Responses to COV Technical Review Comments – Village at Laurel & Jacaranda

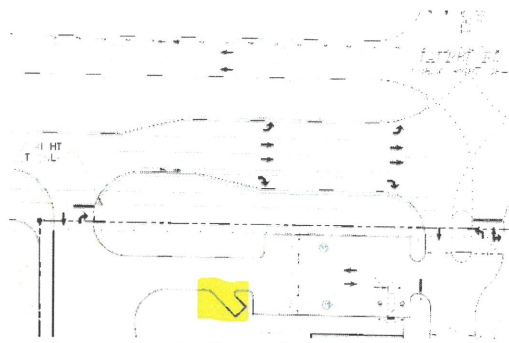
9. Please label the area that is cut out just south of the retail building on the east side of the site and the area in the northwest corner shown here:
Please see updated site plans.
